To all FASTRON Customers

Ref no: 000414

Concerning Part Name : 1206AS and 1206F series

Classification of Change : Dimension of packing material

drawing only schematic, see table

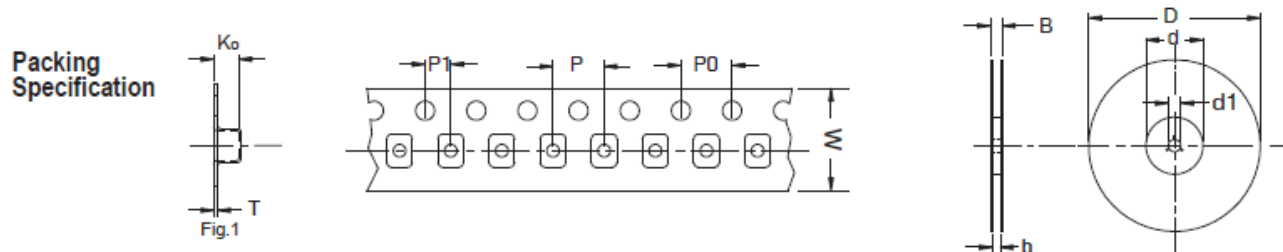
Description of Change : Tape dimensions change from 8 to 12mm width. For the details of change refer to below table, changes are highlighted in blue (B, b, W and T dimensions).

Reason : To improve the sealing strength between the cover and carrier tape.

Old dimensions:

Type	Packing Code	D	d	d1	B	b	W	P	P0	P1	Ko	T	Fig
1206	01	180	60	13	12.7	8.4	8	4	4	2	1.8	0.2	1
1206	04	330	100	13	14.4	8.4	8	4	4	2	1.8	0.2	1

New dimensions:

Type	Packing Code	D	d	d1	B	b	W	P	P0	P1	Ko	T	Fig
1206	01	180	60	13	18.4	13.7	12	4	4	2	1.8	0.3	1
1206	04	330	100	13	18.4	12.4	12	4	4	2	1.8	0.3	1
